ADDENDUM NUMBER 02

DATE: May 12, 2026

PROJECT: **CHEAHA STATE PARK FIRE STATION**

PROJECT NUMBER: **ASPD PROJECT #: 2026-005-16FS**

LEVEL 1 FLOOR PLAN - LIGHTING
 1/4" = 1'-0"

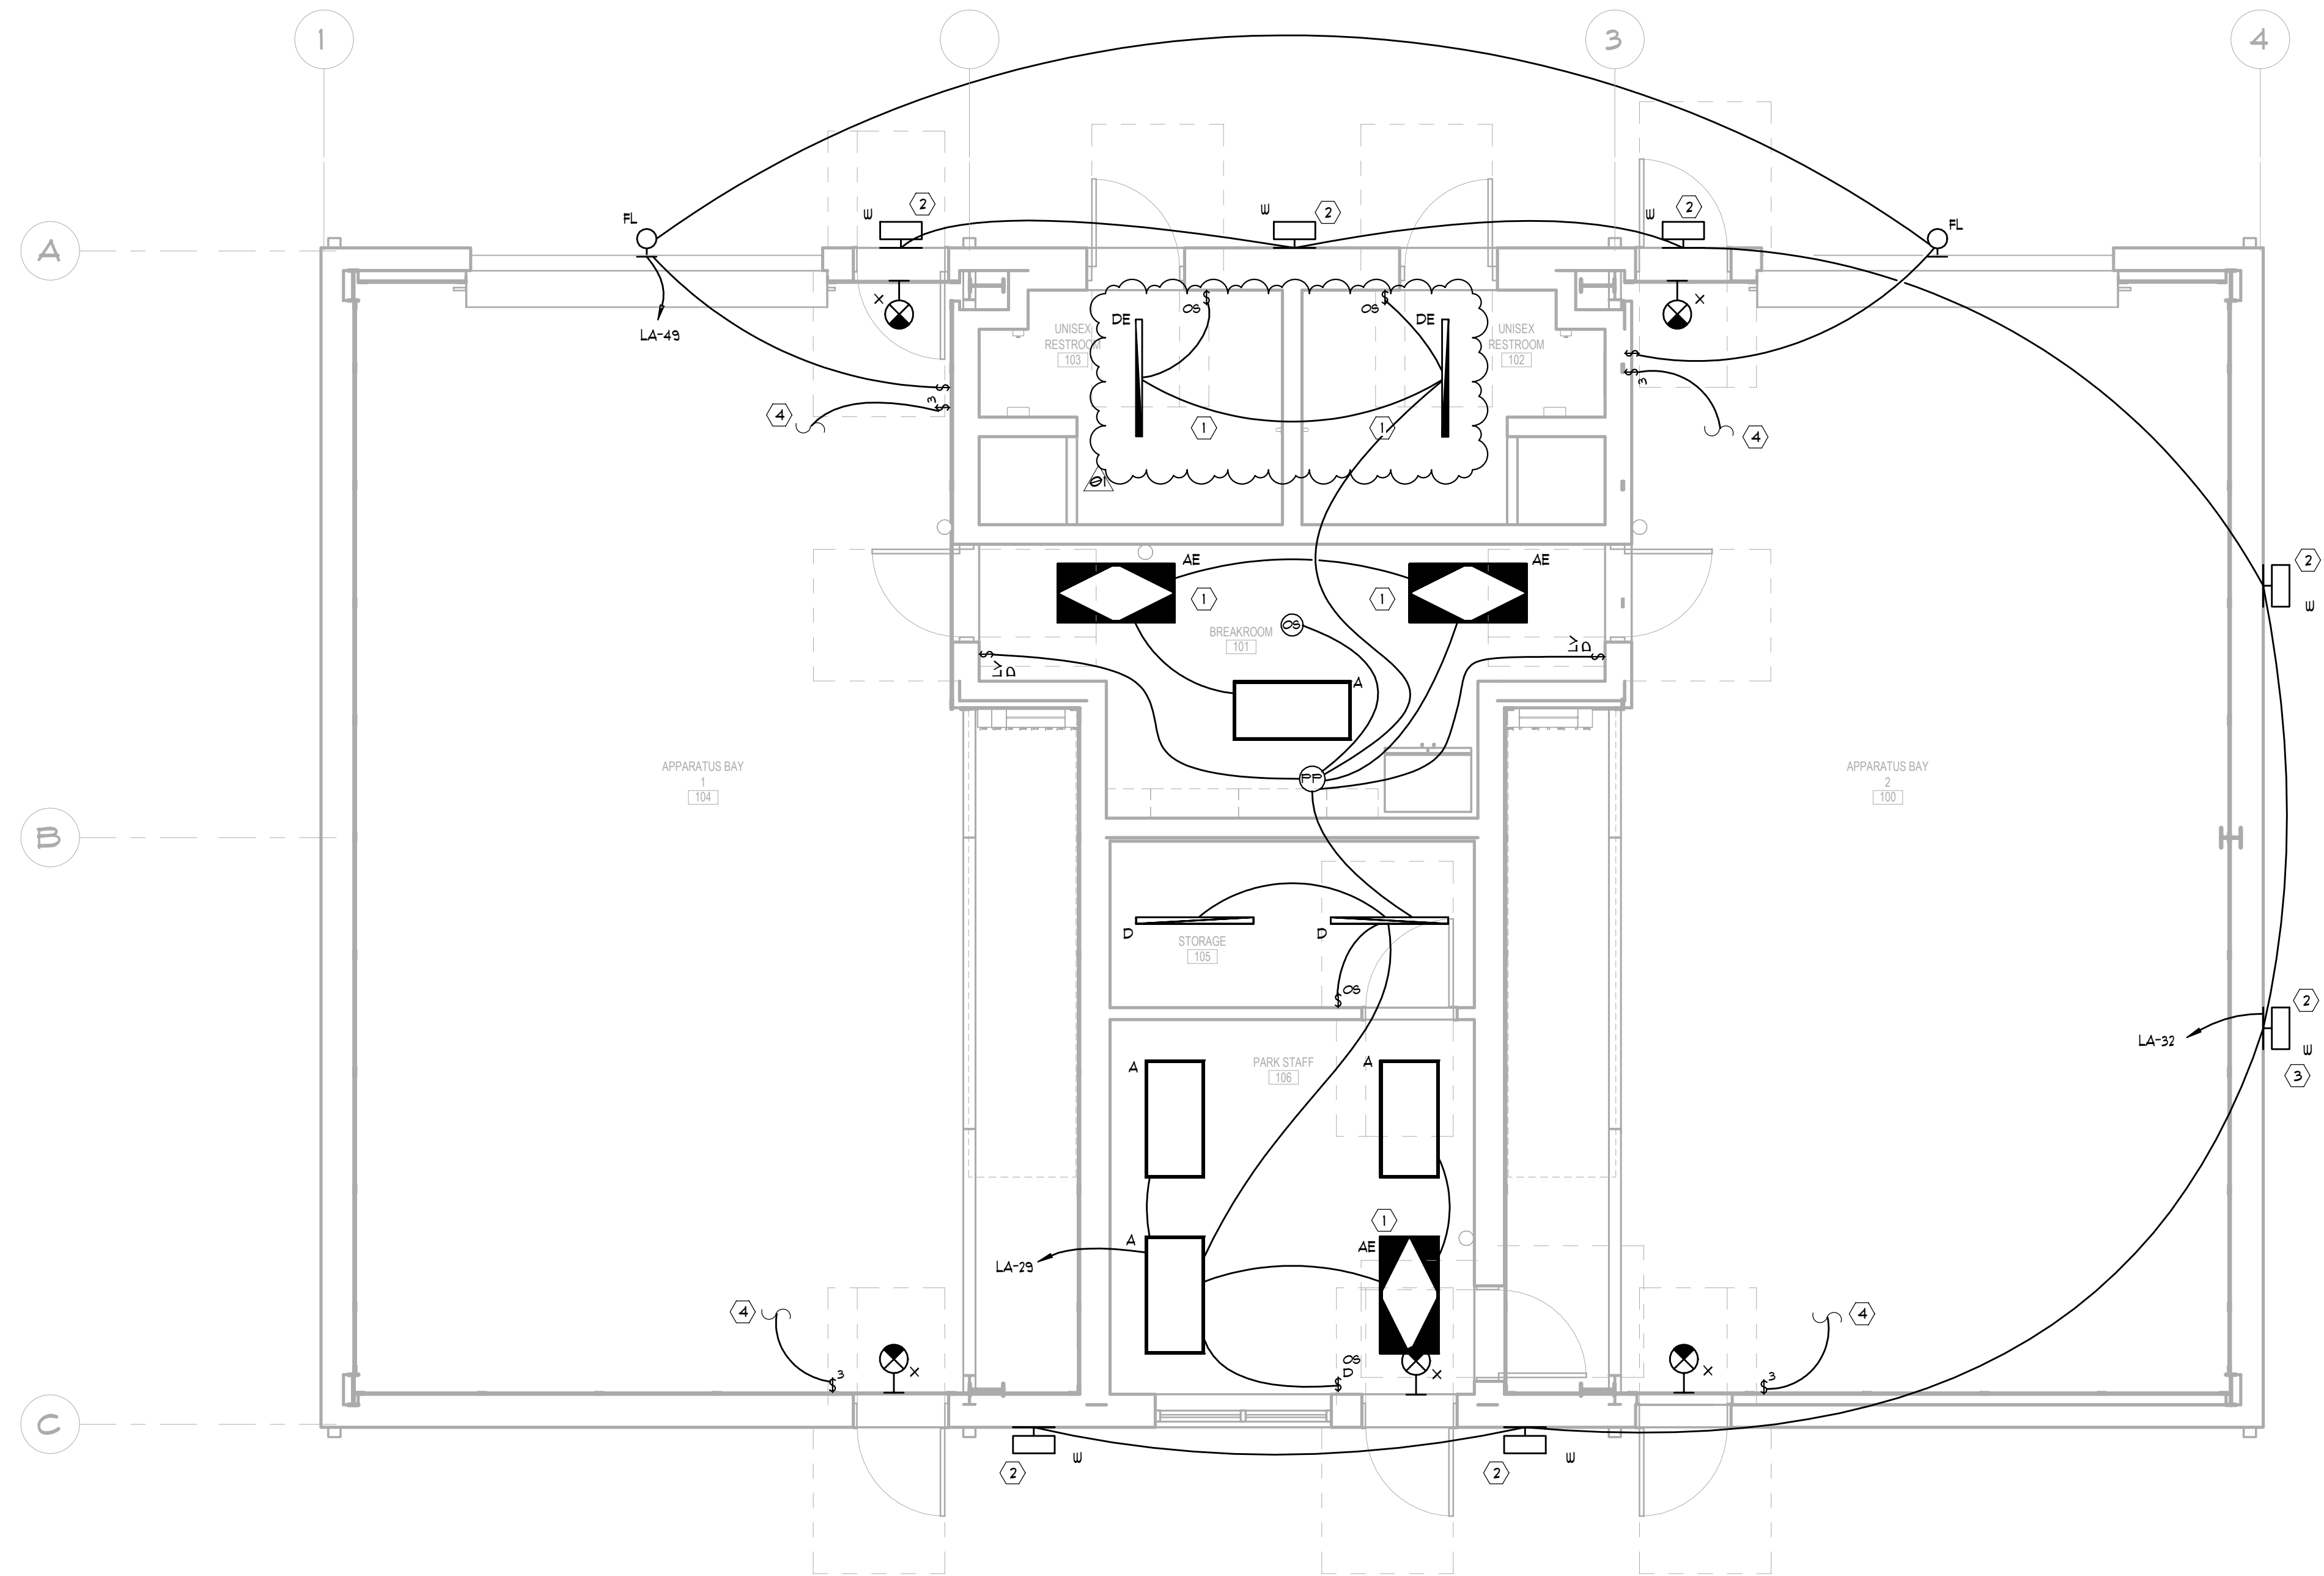
2. **Sheet E08.00 – LEVEL 1 FLOOR PLAN – LIGHTING**
 - a. Replace with the attached drawings; changes are indicated with revision clouds.
3. **Sheet A02-00 – FLOOR PLANS**

PROJECT NO:	R08325001
DATE:	04/17/2026
SHEET NO:	AS SHOWN
A02.00	
FLOOR PLANS

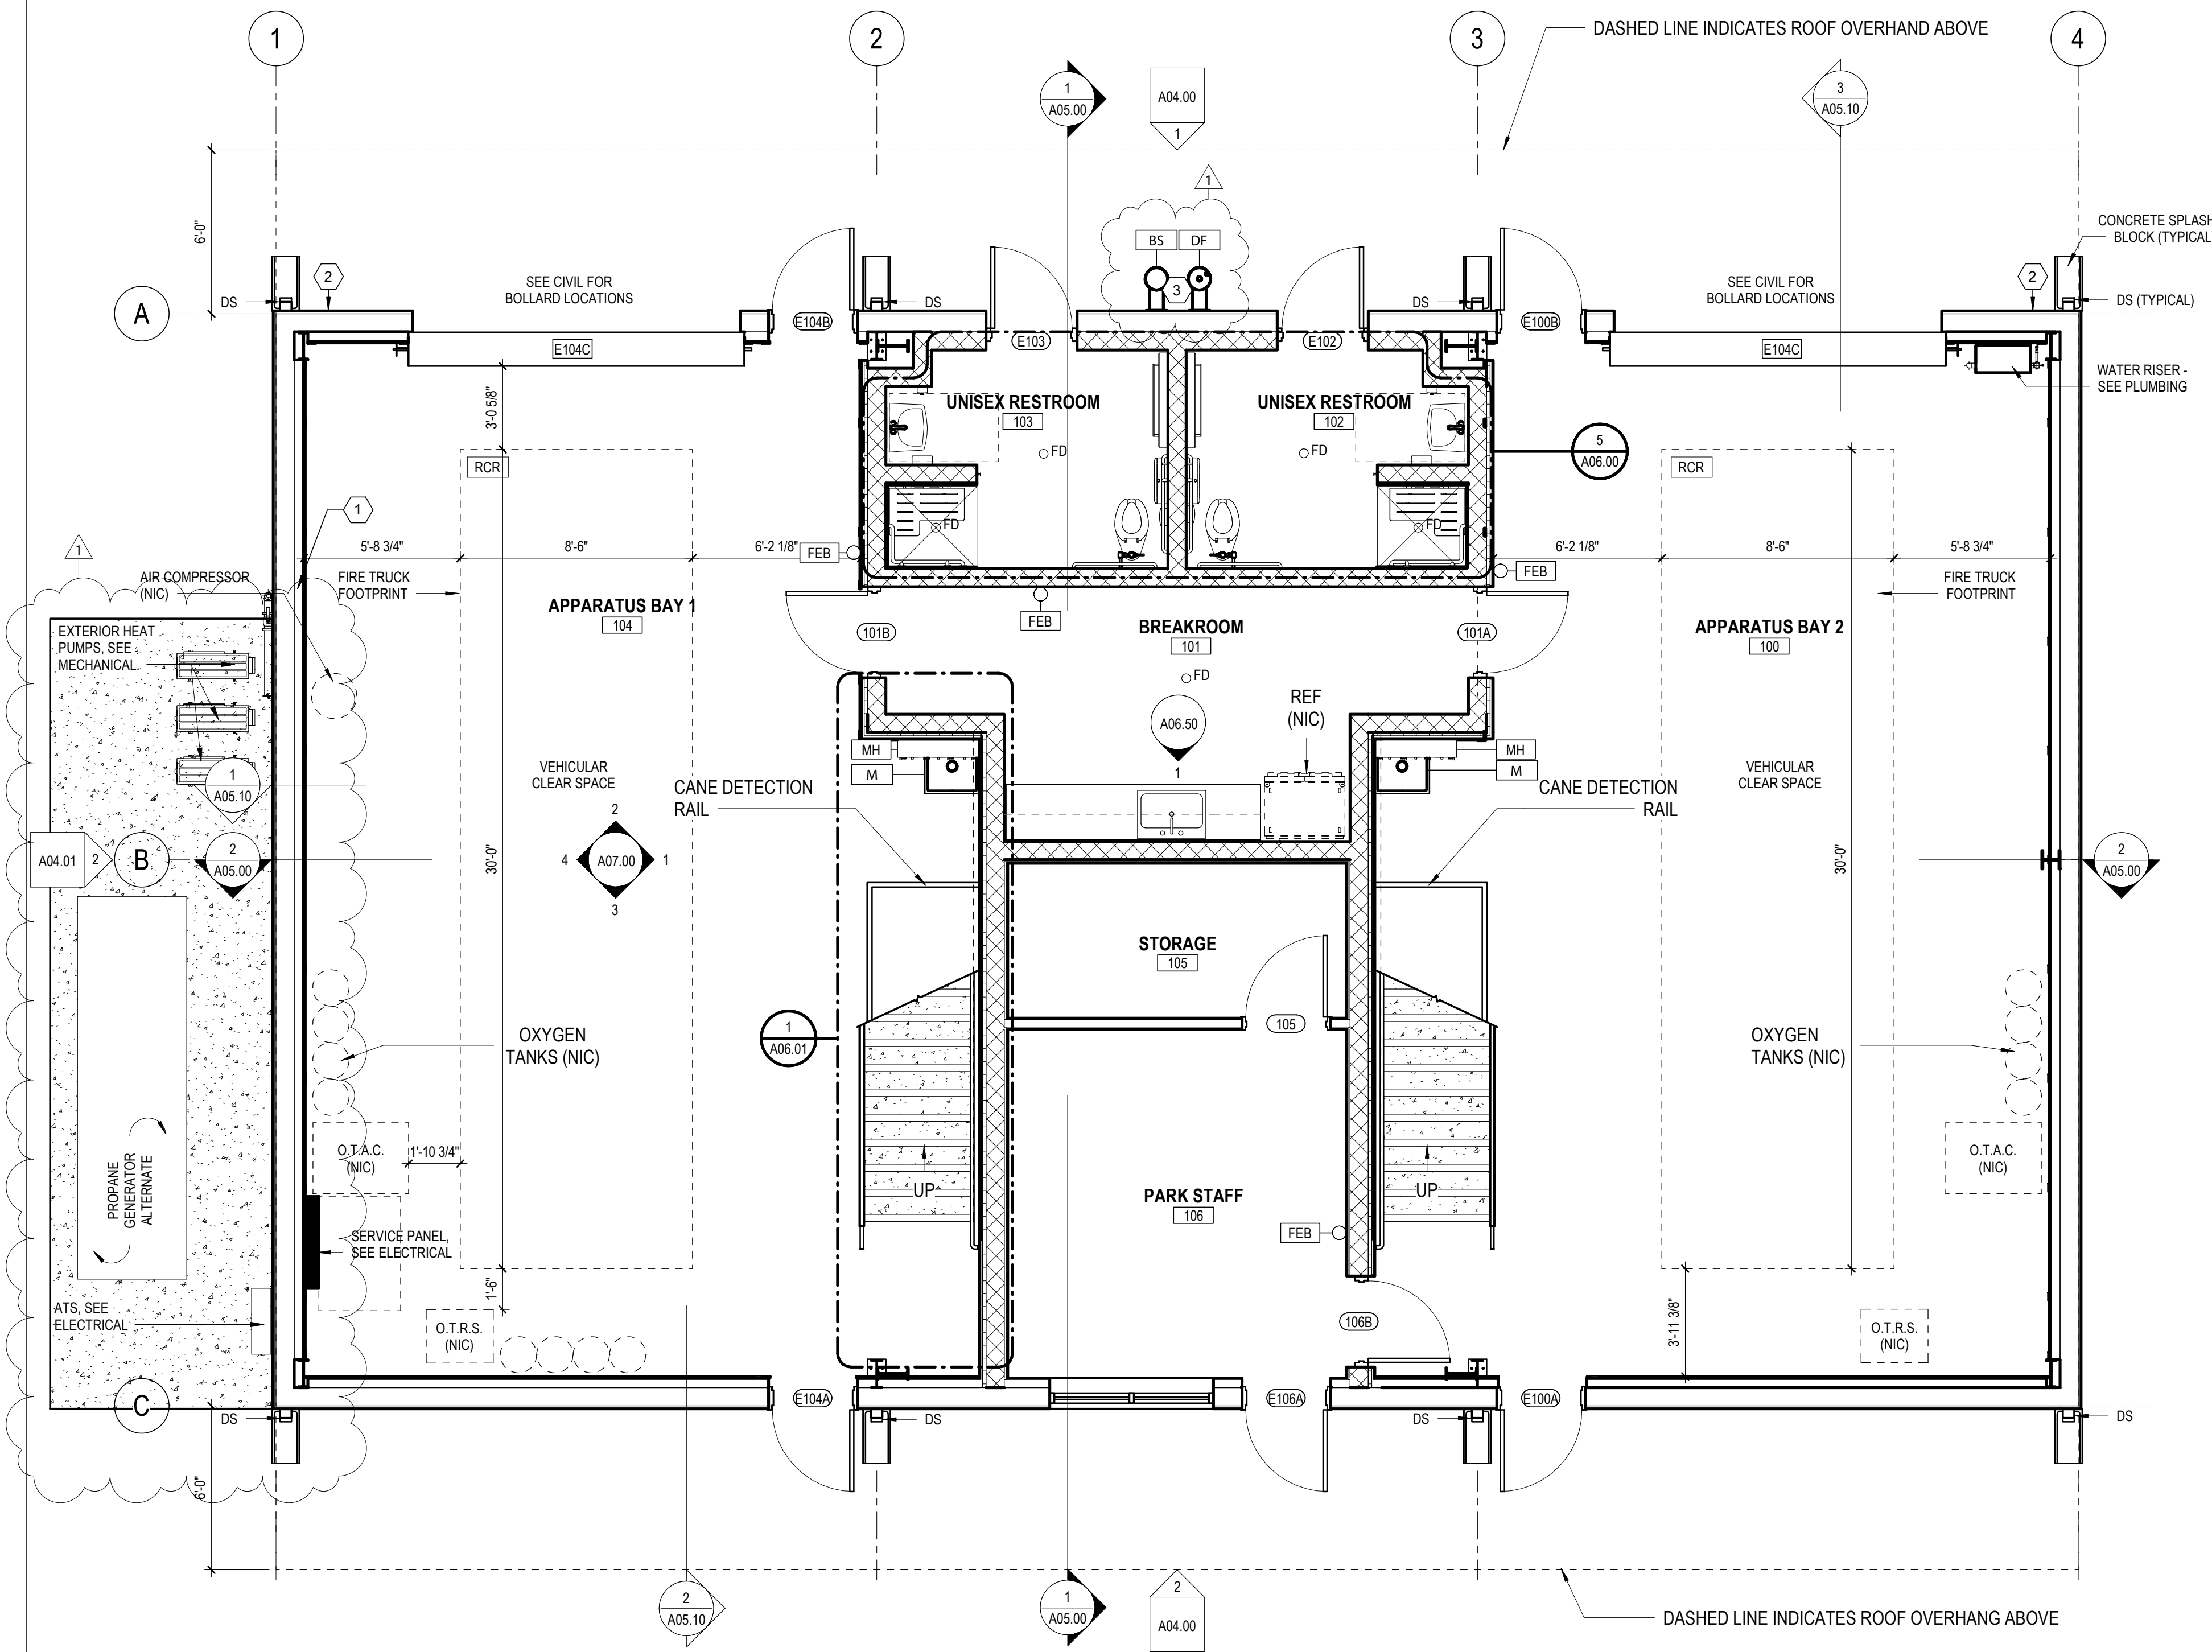
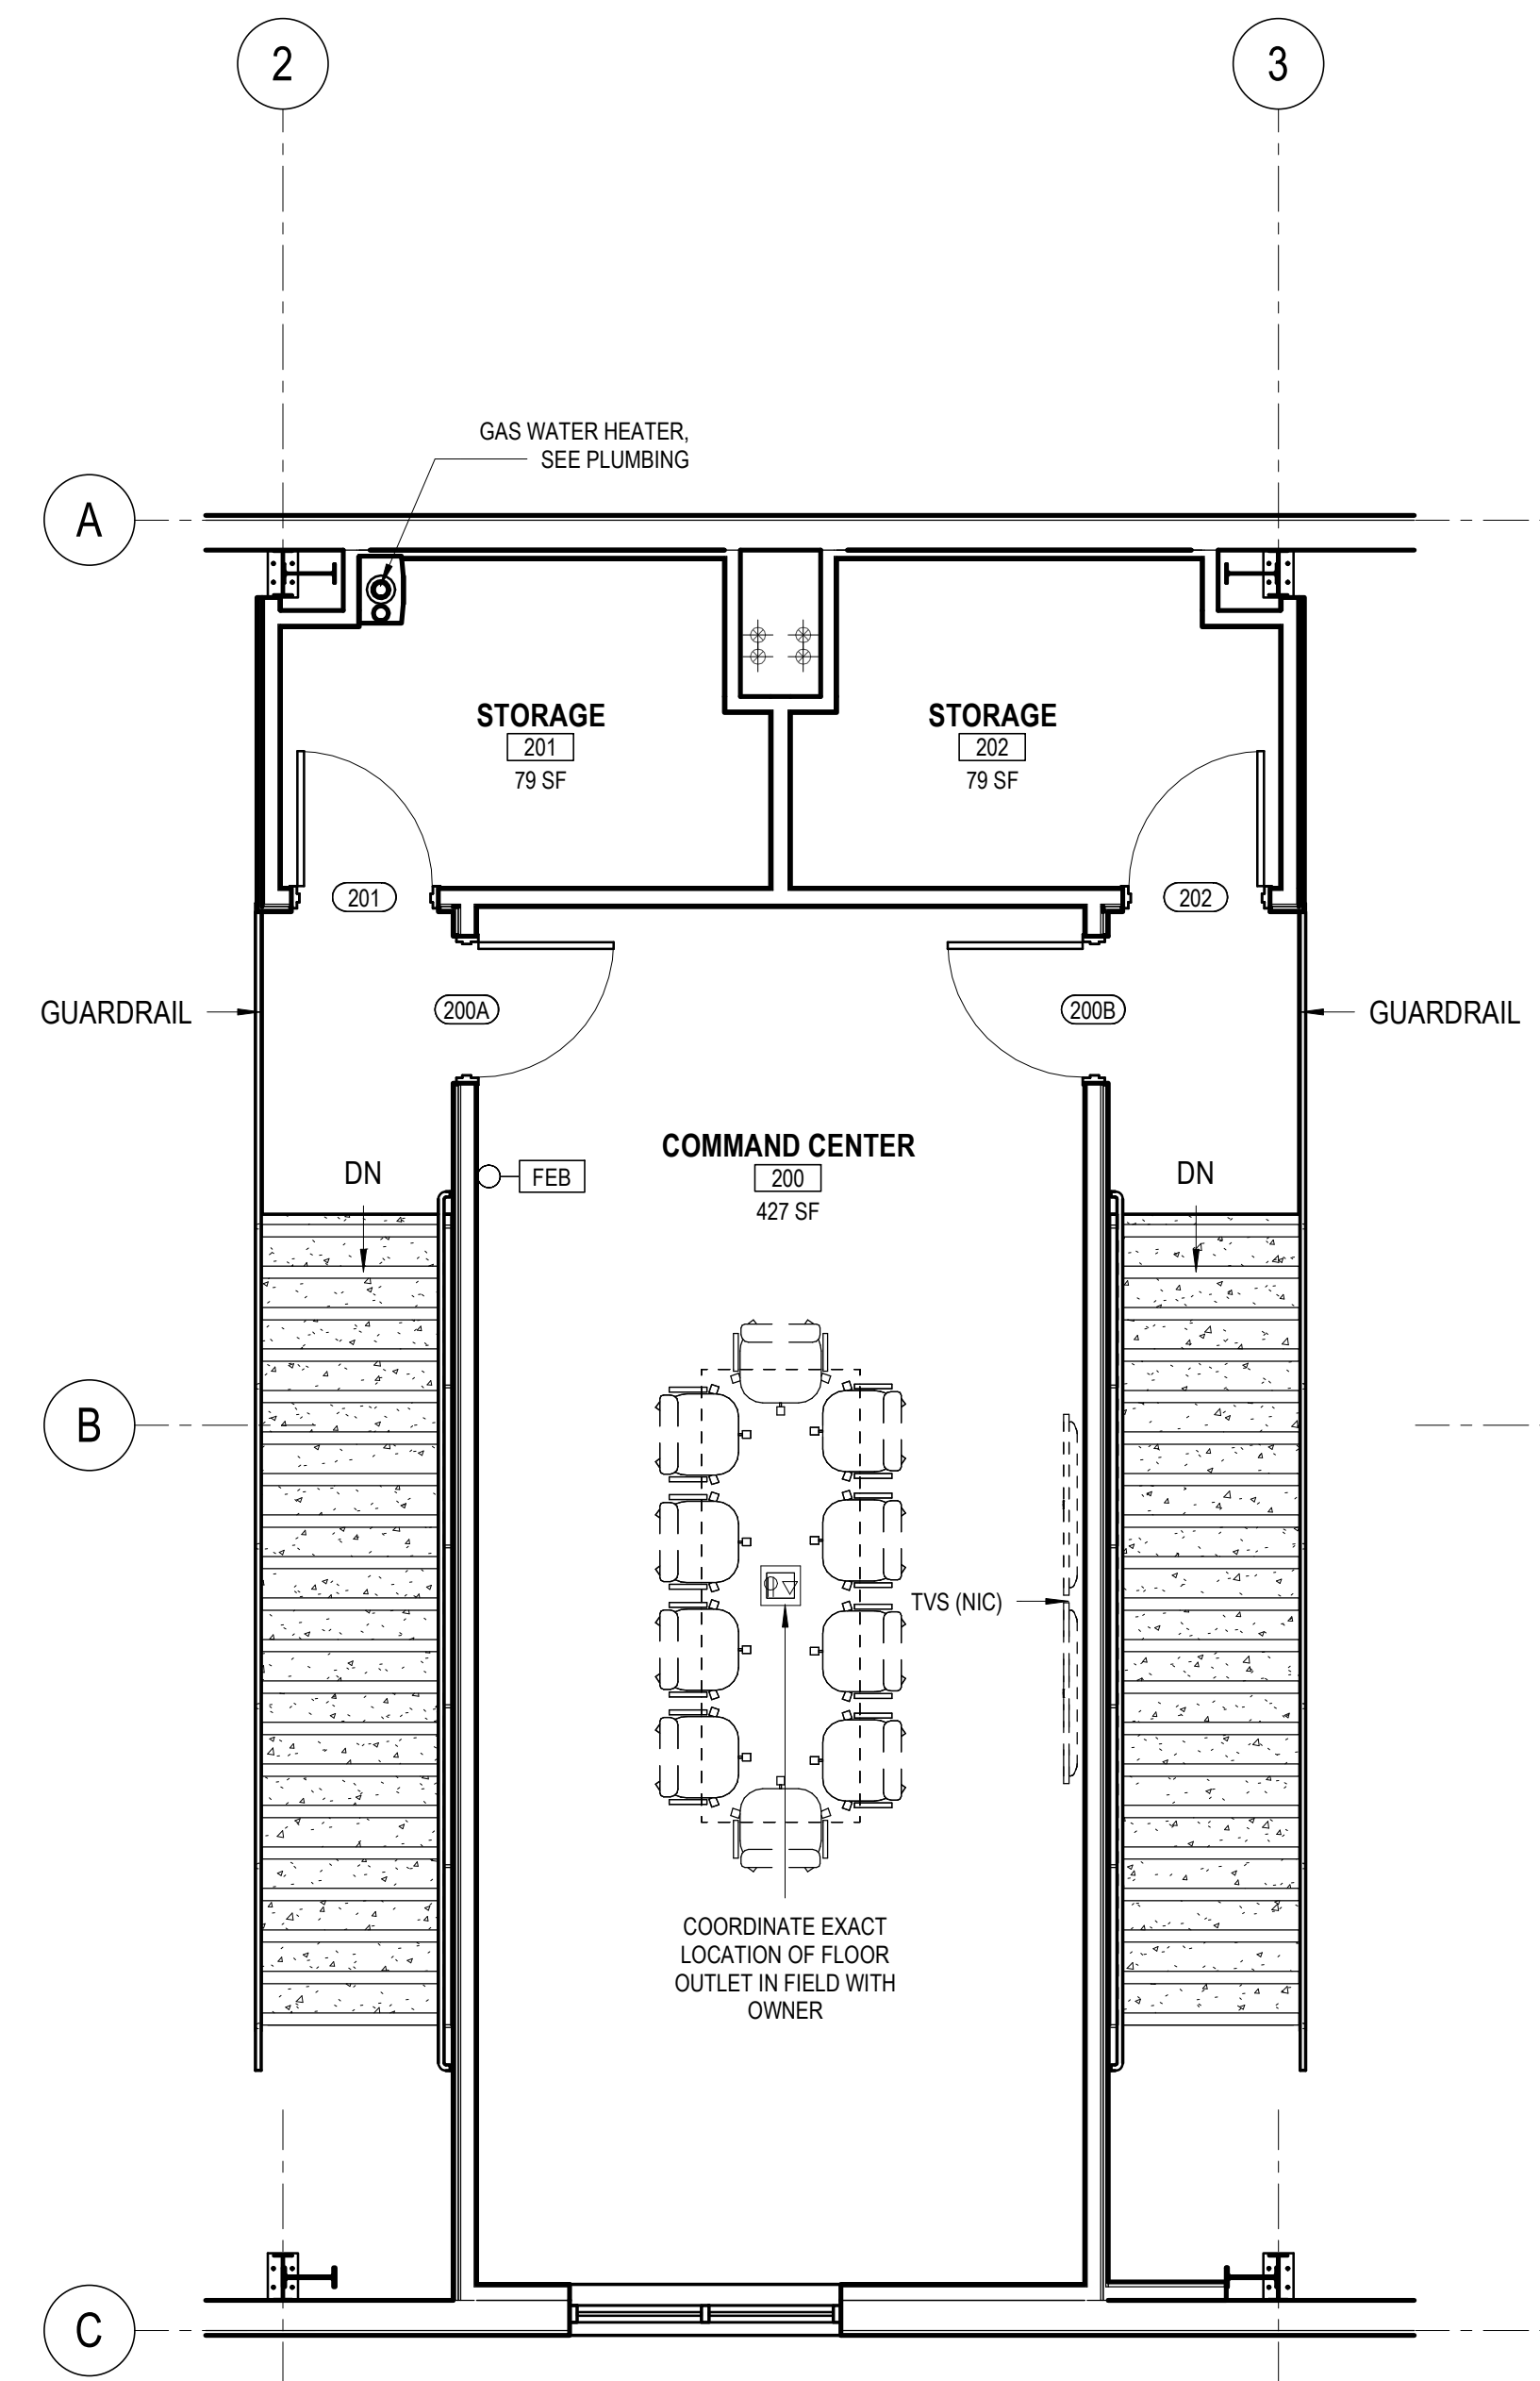
- a. Replace with the attached revised drawing.
 - b. Revision cloud reflects layout of mechanical pad and bottle filling station/ drinking fountain. Specific note added to sheet.
